PERMIT APPLICATION FOR A RESIDENTIAL SITE IMPROVEMENT PERMIT / CONSTRUCTION AUTHORIZATION FOR ON-SITE WASTEWATER SYSTEM NEW WELL INSTALLATION OR REPAIR OF EXISTING WELL MECKLENBURG COUNTY GROUNDWATER & WASTEWATER SERVICES

13608 Sage Thresher

RE: Request for a Revision to Improvement Permit for Lot 173 at The Sanctuary:
MCHD File #5765B

THE CORBIN RESIDENCE

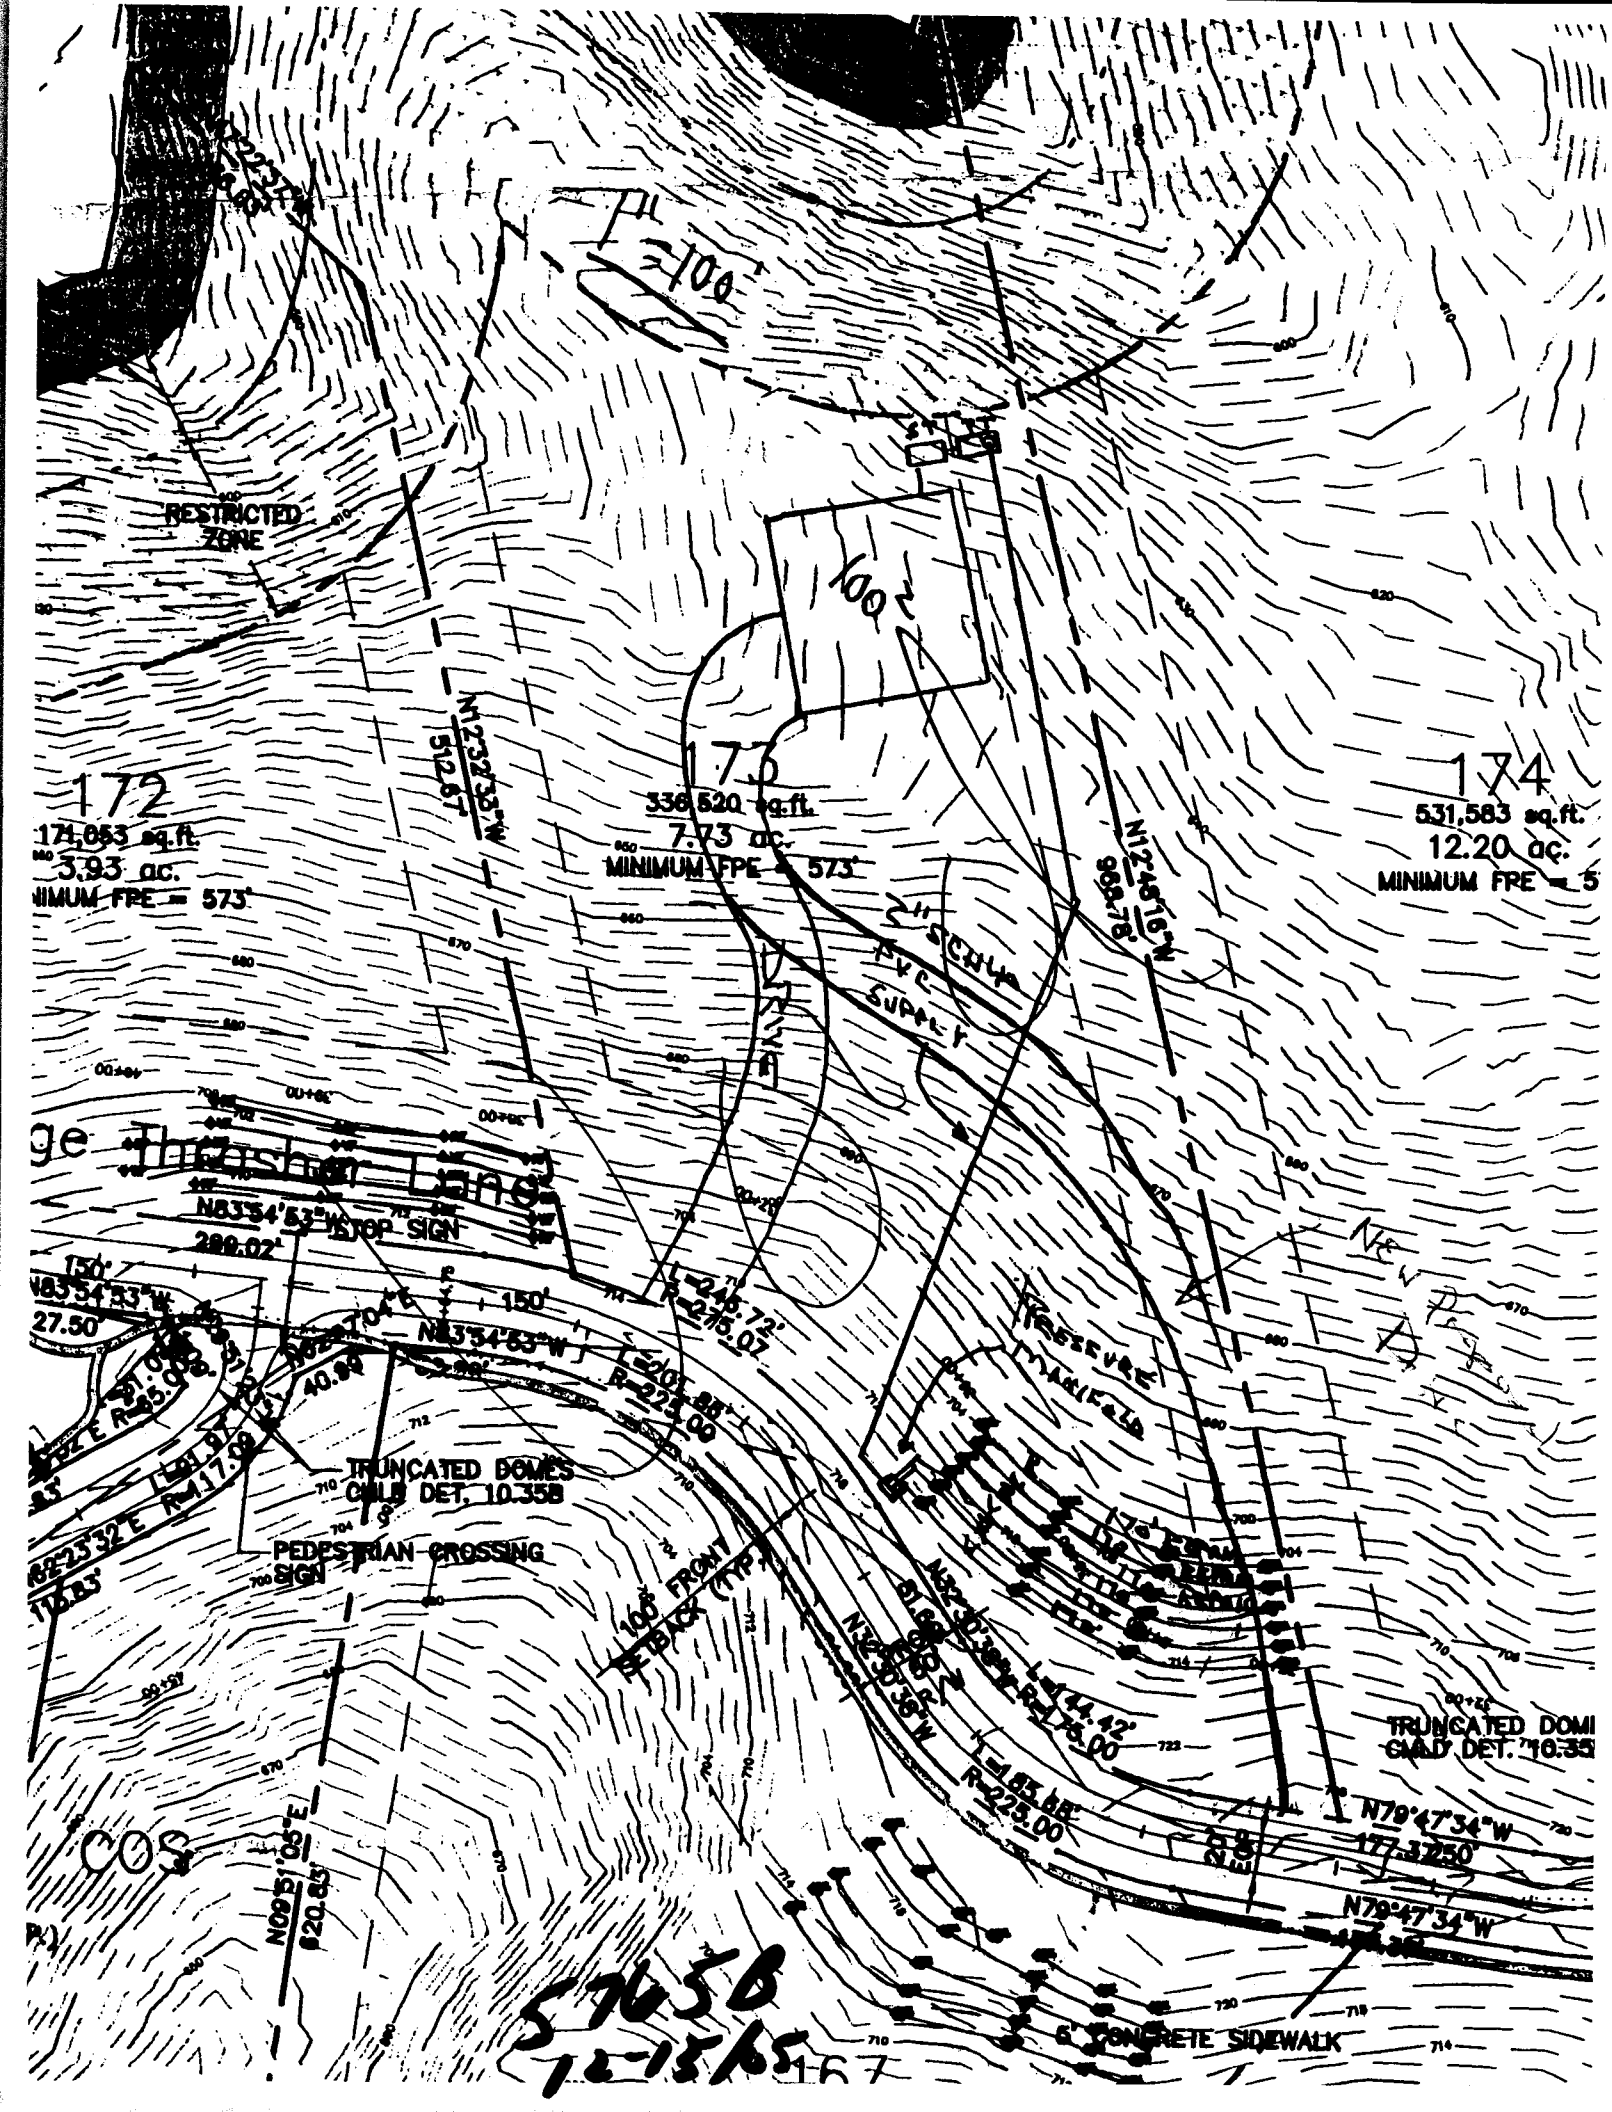
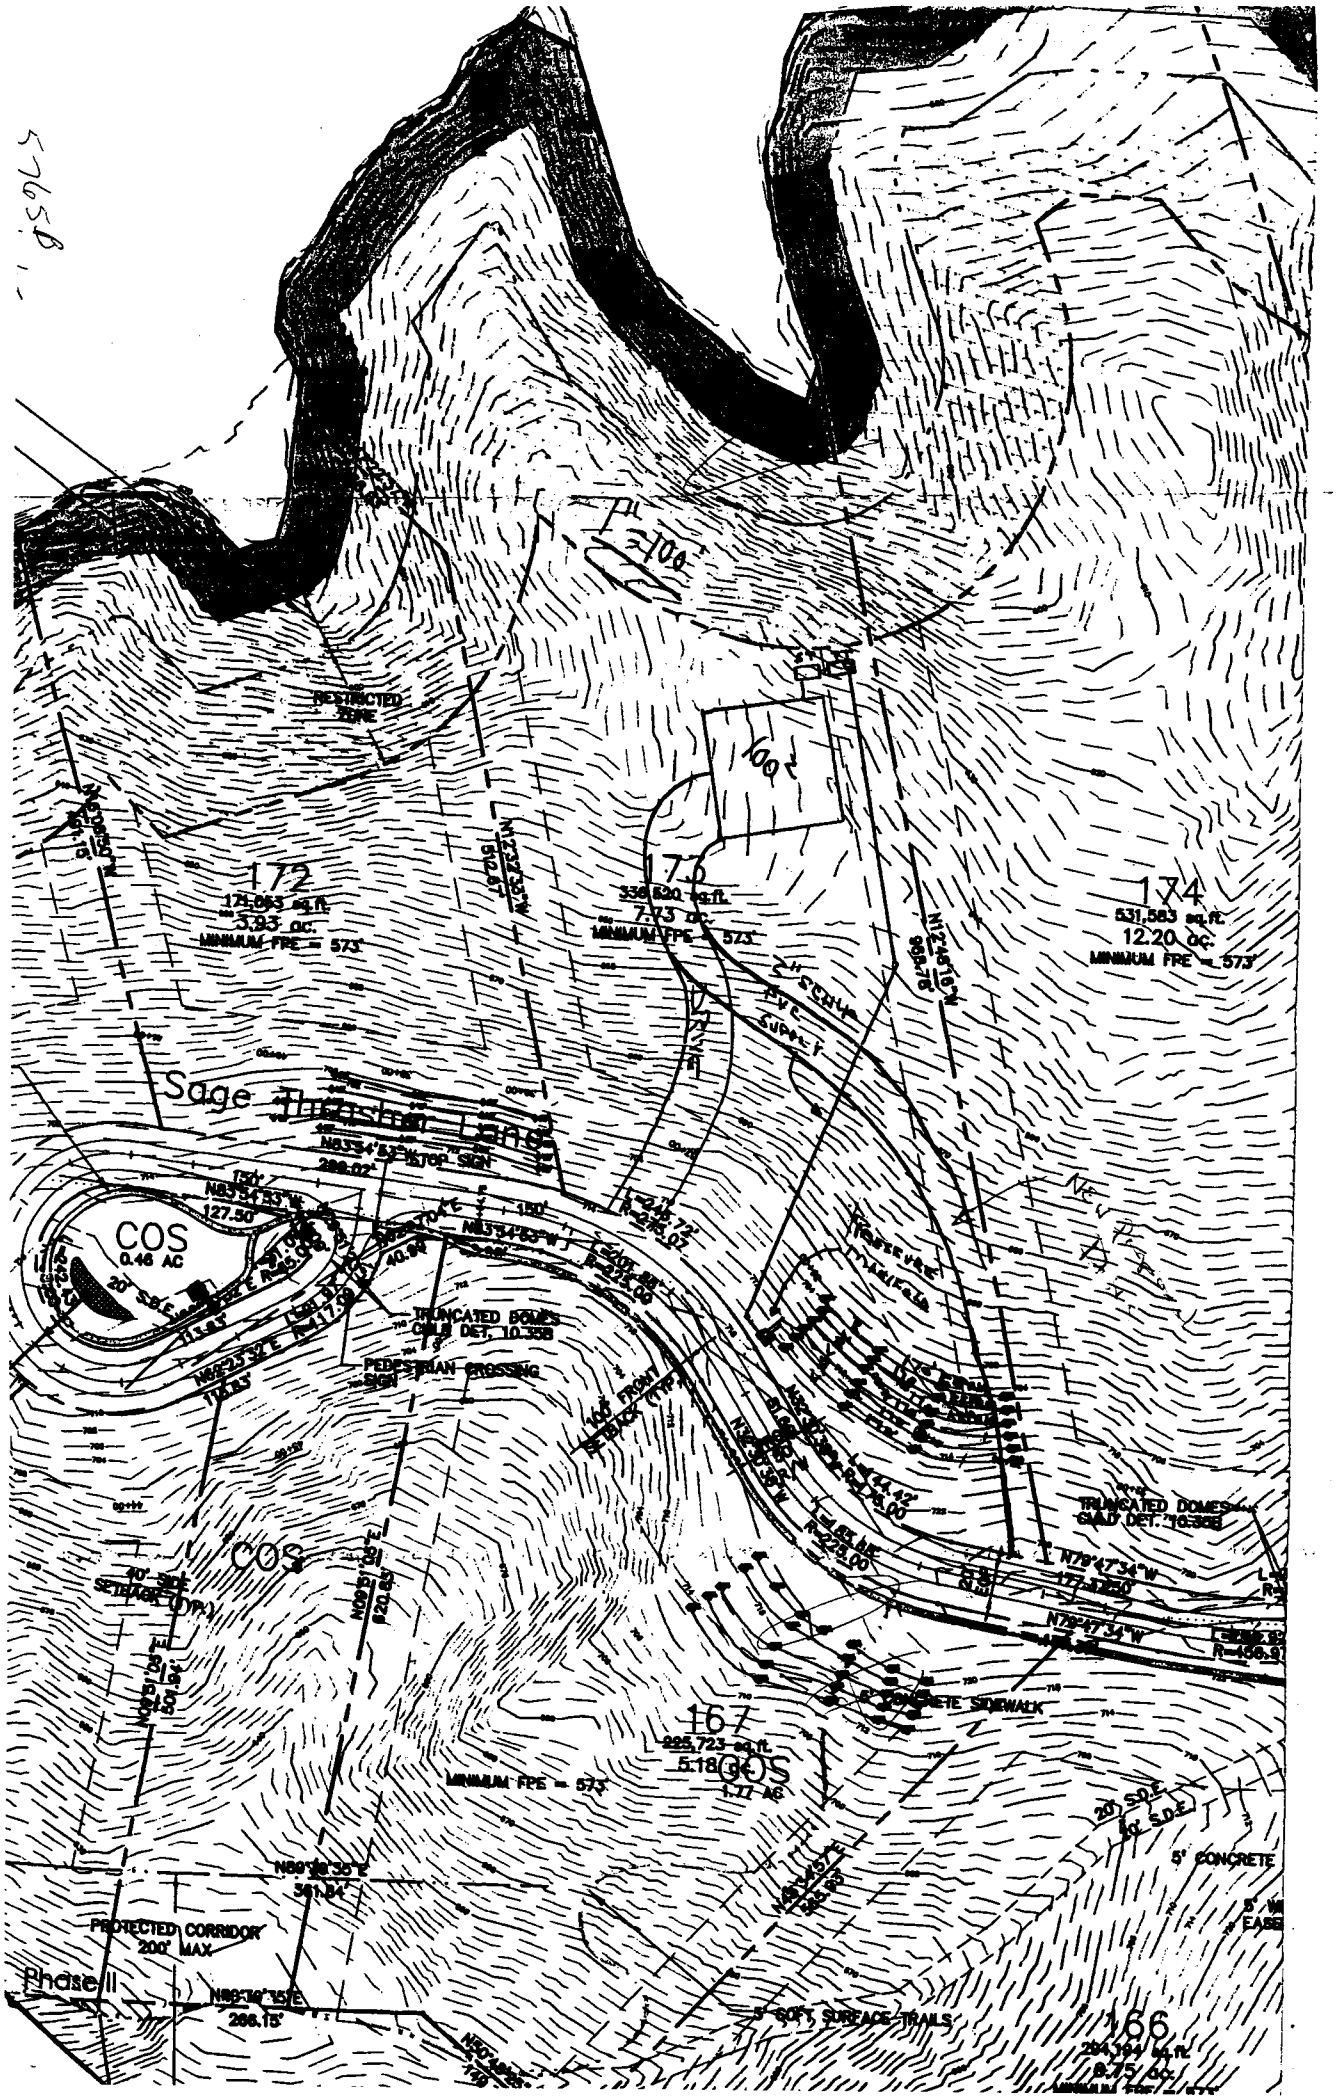
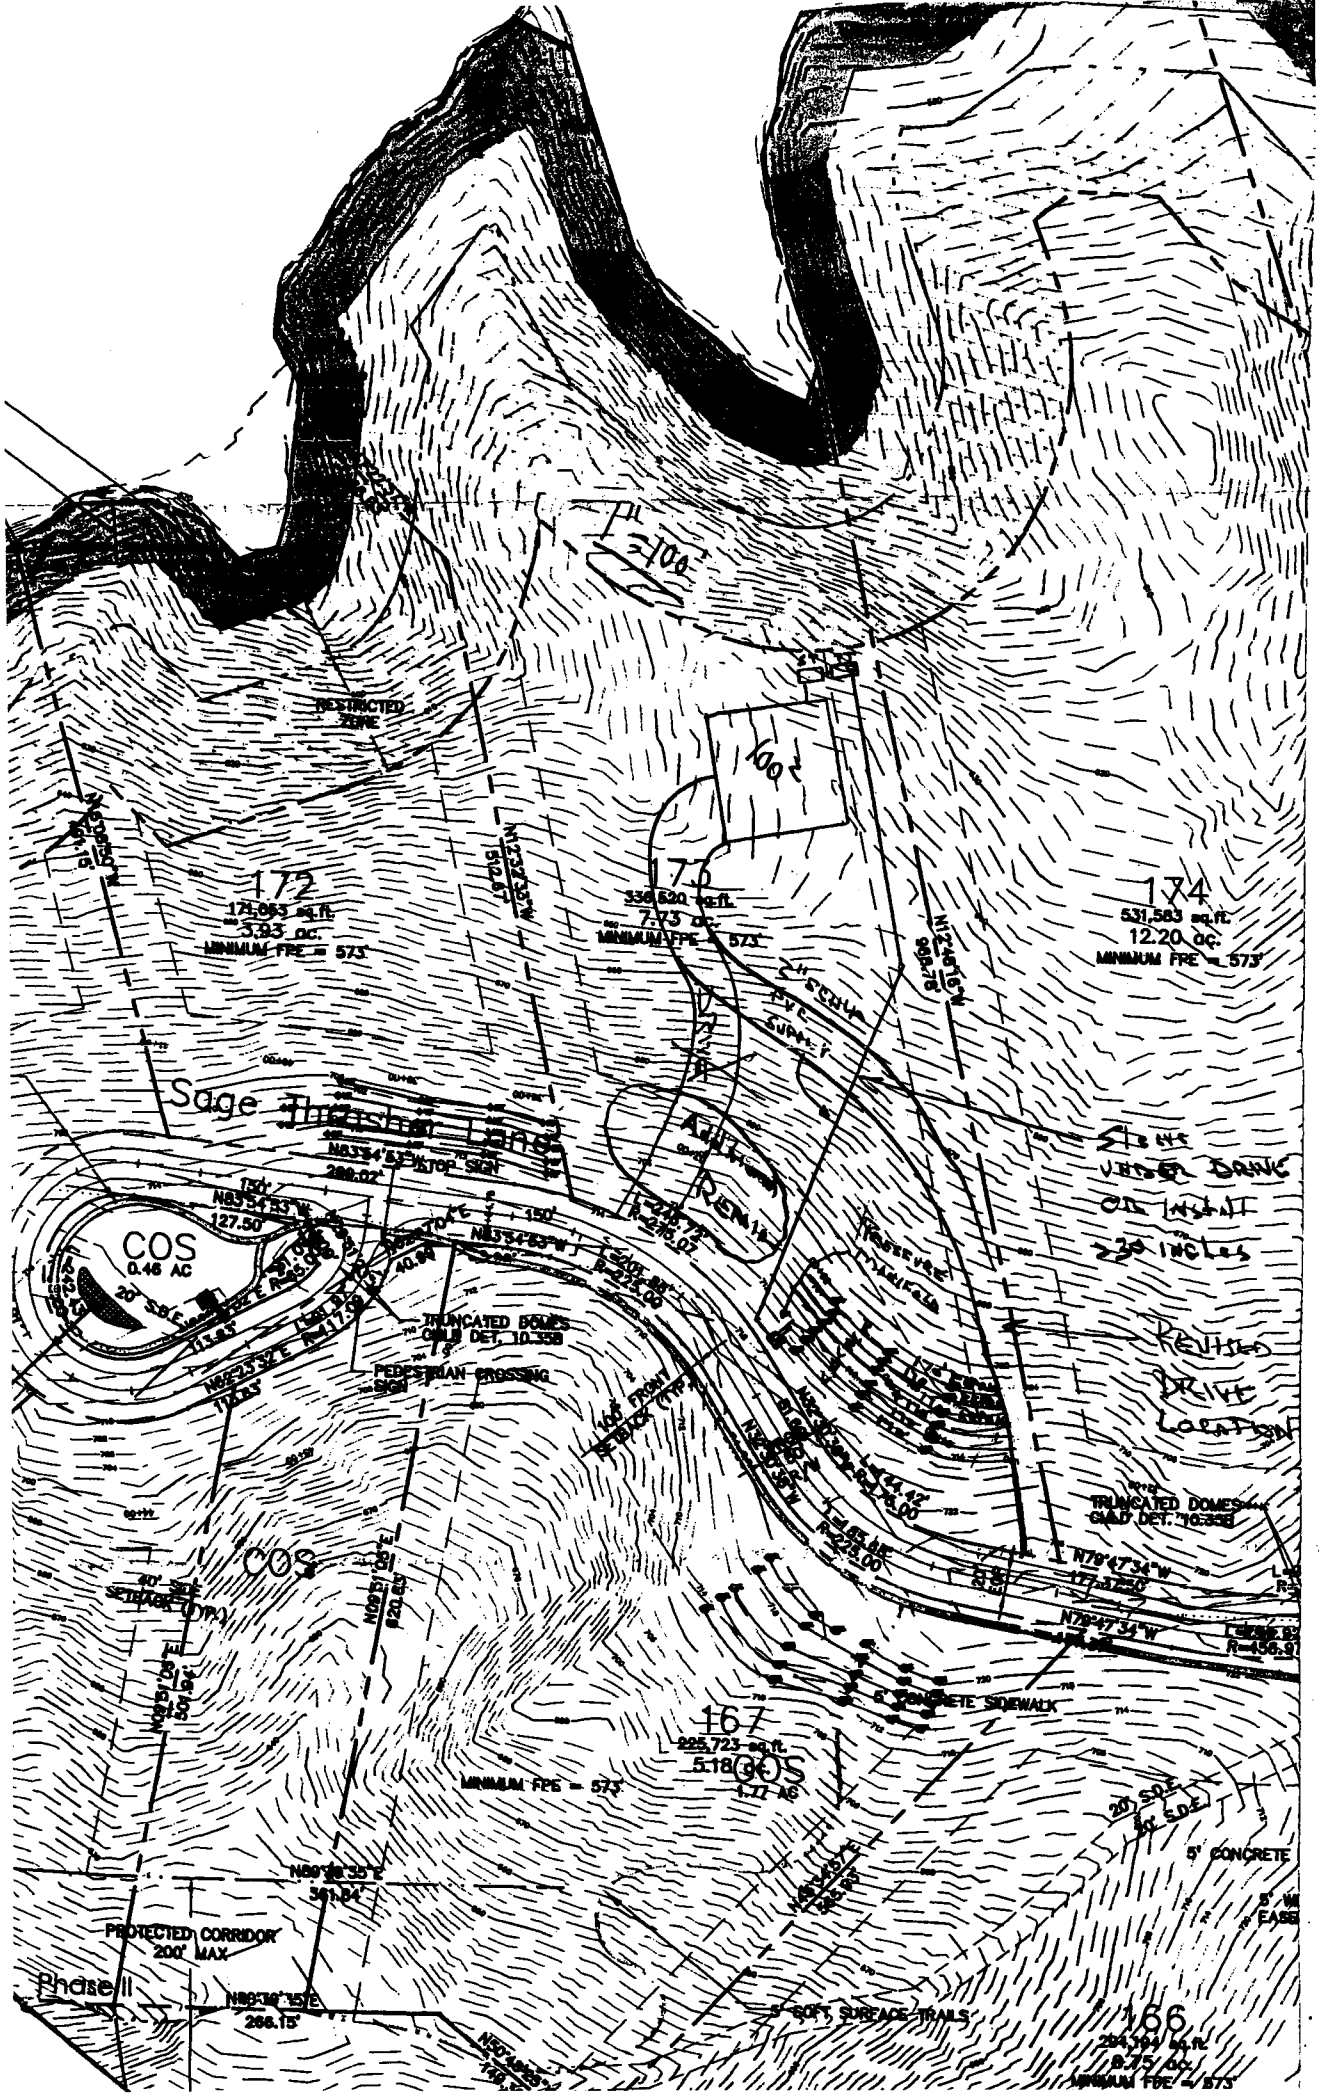
The Sanctuary at Lake Wylie is requesting a revision to the Improvement Permit for the above referenced lot. Mr. Bill Marlin has evaluated the soils (see attached MCHD soil sheets) and S&ME, Inc. has flagged the system and repair on the septic area. The septic lines have been located by the surveyor and are shown on the attached maps. The attached sketch and specifications are not an Improvement Permit and are intended only to assist the MCHD in permitting the referenced lot at The Sanctuary. The only revision being requested is that the developer has moved the proposed drive to the right property line. The drive has been cut in and graveled for a short distance as shown on the attached site plan. The developer did this to aide potential buyers in accessing the lot. The primary system can remain as permitted originally. Addition length was added to the left side of the repair lines to make up for length lost to the new drive. There is additional repair at the area where the drive was originally proposed.
